411 Main Street LLC Business Park Access

Environmental Review Team Report

Report #593

December 2005

411 Main, LLC Conceptual Site Plan 4/29/04

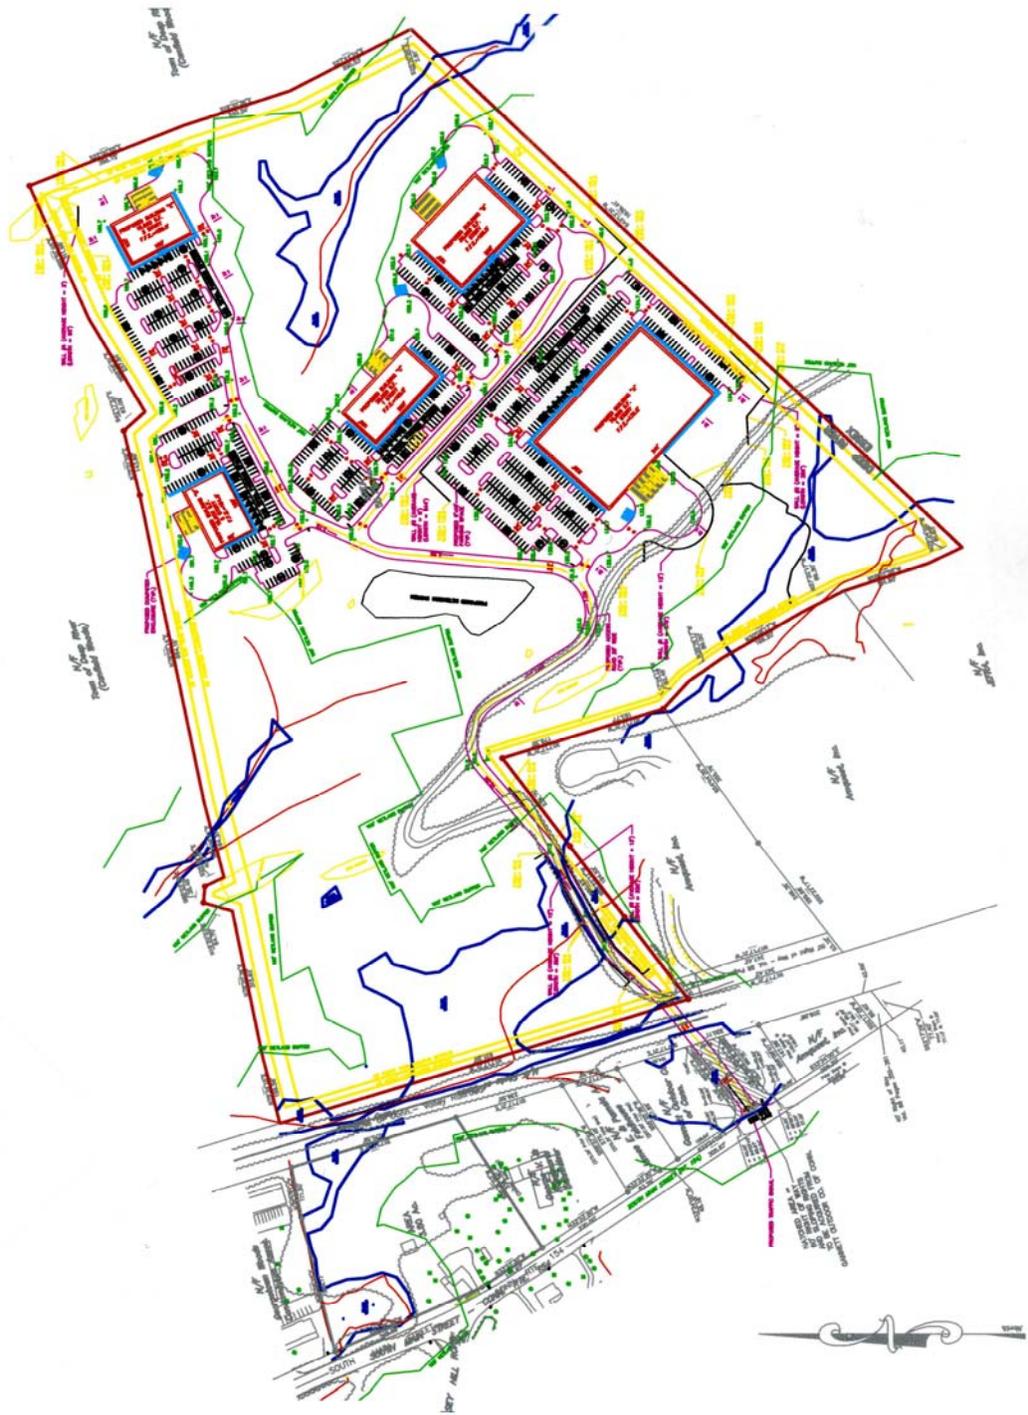
1. Although conceptual only, the northern access appears to be favorable to the southern access. Because the wetlands are narrower, and are mostly confined to the area already disturbed adjacent to the railroad tracks, this option should require less total wetlands impact. The southern access would require a wider wetlands crossing and possibly the use of extensive retaining walls. Structural retaining walls will bisect the wetlands and possibly sever the north/south connectivity of the wetlands corridor. The total amount of wetland impact for the northern access can only be determined once there are engineered plans (even if preliminary in nature as there are for the southern access road).

3. The westernmost development pod is situated at the edge of a steep slope in close proximity to the downgradient wetland (50-100 feet). This pod should be eliminated due to the potential for both short term (during construction) and long term (post-construction) adverse impacts of permanently disturbing an area that drains over steep slopes to the wetlands below.

4. A single large stormwater detention facility is shown on the conceptual plans. Alternative and low impact development techniques should be used to design a plan that balances protection of natural resources with economic goals for the proposed business park.

- a. Design the development pods to best “fit the terrain” in order to reduce the total amount of land disturbed (cleared/graded) and to protect the most vulnerable and sensitive areas.

- b. Maintain wide vegetated buffers to on-site wetlands and watercourses. The width of intact (undisturbed) buffers that remains should be based on the steepness of the slopes and the erodibility of the soils (see the CT DEP upland review areas guidance document).

- c. Preserve the site’s pre-development hydrology in order retain hydrologic conditions in downgradient receiving waters.
 - d. Minimize the total amount of impervious surfaces (e.g., roofs, roads, parking areas) to the greatest extent practical. Consider using pervious paving materials for overflow

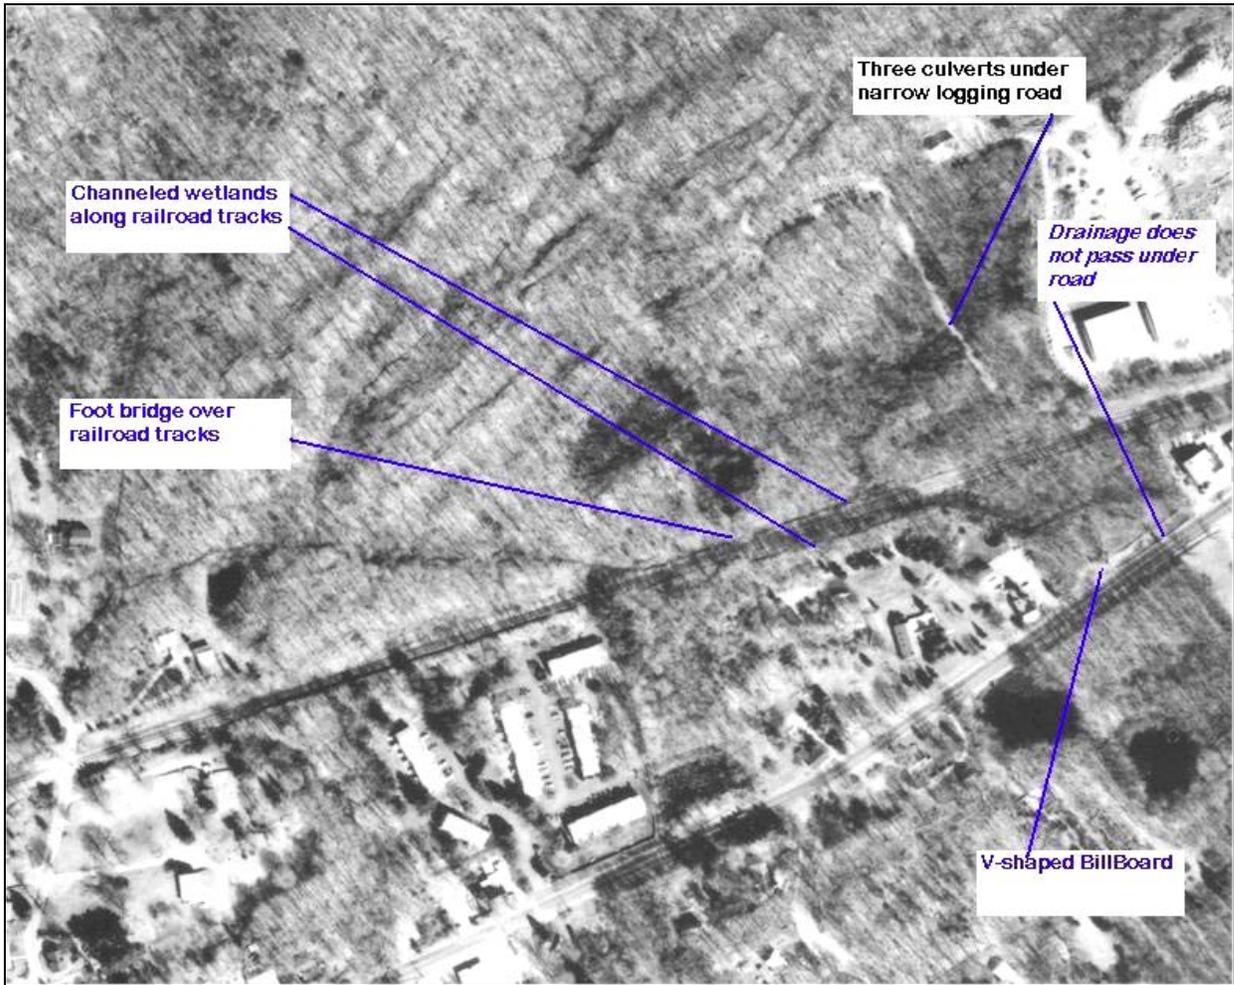
Road B cuts across the greatest area of wetland and would have the most far-reaching impact on the health of the wetland system. This reviewer does not consider proposed road “B” as a viable option.

Road C poses an interesting scenario in that it impacts headwaters portions of the wetland systems on both sides of the RR tracks.

In this proposal, a one lane logging road bed is already in place. However, this road, as it comes down off the uplands onto the level where the three culvert crossing occurs, is very steep. In addition, it would have to be widened considerably to meet local regulations. Given the amount of sand and salt needed to keep a road of this type passable in the cold months, the construction needed improve the road to a minimal two lane standard, and the water flow rate so low that the wetland would have no possibility of cleansing itself of accumulated sands and silts, this road cannot be considered and viable option.

Proposed roadway ‘A’ *could* potentially have the most minimal impact on the wetlands system depending on exactly where it is built. Again, the broken wetland delineation lines on the maps make it especially difficult to ascertain the exact field locations for analyzing any proposal. However, there is a point in this wetland system that tapers to a very narrow waterway.

If a road does cross this wetland, it is imperative that it pass over the narrowest wetland channel in this area to minimize impact. In general, this location can be described as the area east-north-east of the house opposite Kelsey Hill Road. The path is essentially through the back yard of this property and in the general vicinity of the footbridge pictured above. (Discussion with team members described a paper road that passes through this property as it continues east from Kelsey Hill Road.) However, these wetland areas can be extensive when flooded because of the level terrain and, as a result, must be walked by the commission in a wet period to more fully understand the wetlands that will be impacted. Only then can the best roadway path be specified and a decision made for the final plan.

FIGURE 1

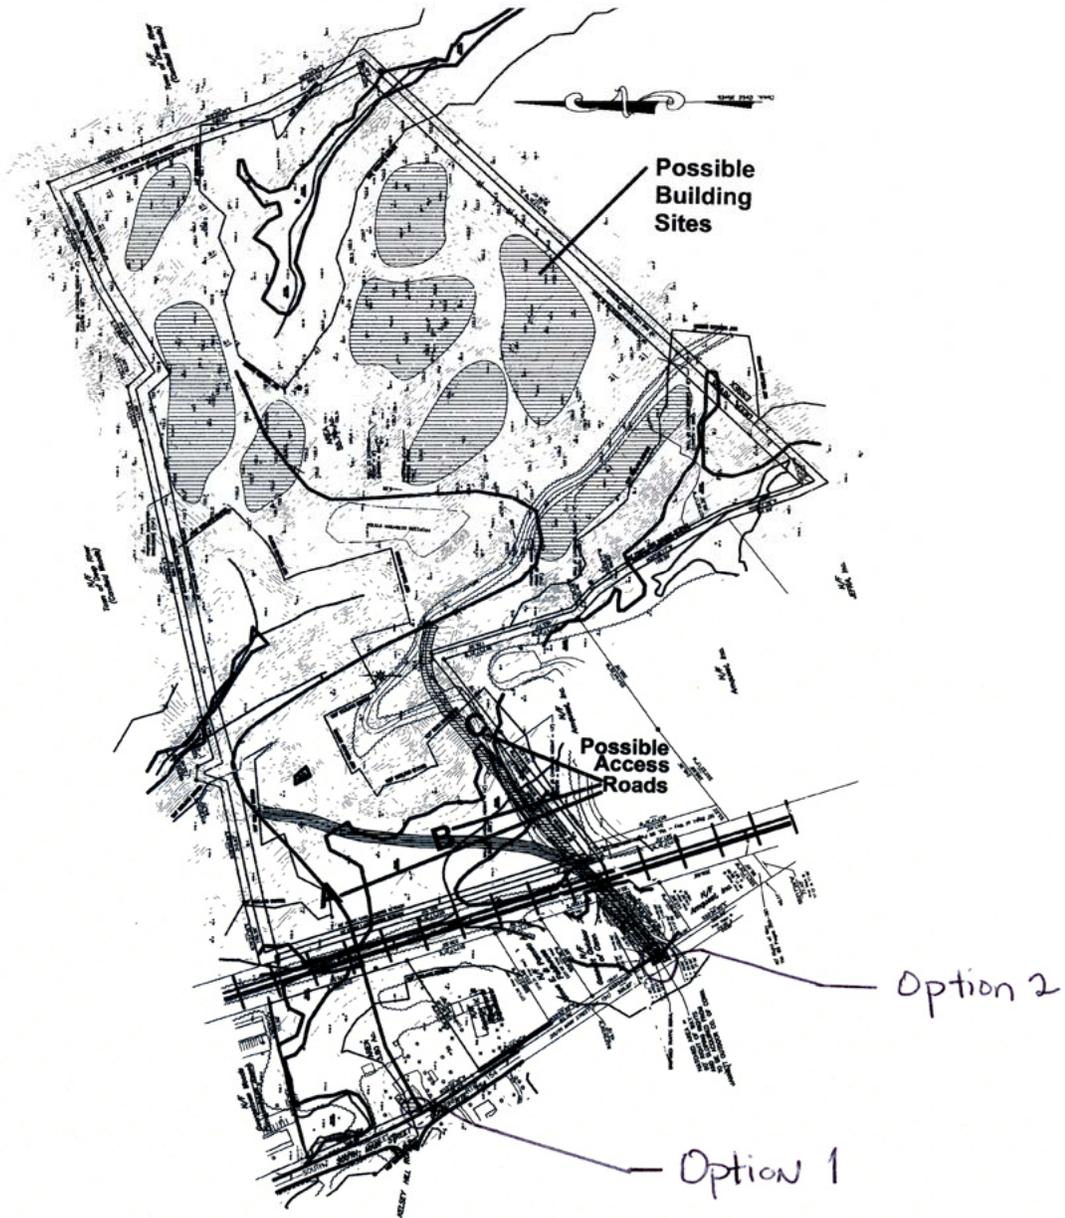
Figure 1 shows the conceptual site plan for a 155,000 sq.ft. business park the developer submitted to the Environmental Review Team for review and comment. The site plan includes two potential access locations along Route 154, which are shown as Options 1 (Roadway A) and 2 (Roadways B&C) in Figure 2. The Option 1 access location is near the intersection of Kelsey Hill Road and Route 154. The Option 2 location is at a location along Route 154 where there are billboards, just north of an existing stop-controlled business park driveway.

The 2003 average daily traffic volumes within the vicinity of the site are shown in Figure 2. Preliminary site analysis, using the ITE Trip Generation Model, indicates that the business park will generate approximately 2500 trips per day.

The development, as proposed, would meet the general requirements for obtaining a certificate of operation from the State Traffic Commission (STC) under Section 14-311 of the Connecticut General Statutes. This law requires that developments generating large volumes of traffic on state roadways obtain a certificate of operation from the STC. This statute pertains to developments with a minimum gross floor area of 100,000 sq. ft. or providing 200 parking spaces, having access on state highway, abutting a state highway, or substantially impacting state highway traffic.

It is recommended that the professional services of a traffic engineer be obtained to perform a traffic analysis that quantifies the impacts associated with the development. This analysis will include identifying existing roadway traffic and expected site generated traffic during a typical day, and during morning and afternoon peak hour traffic periods; capacity
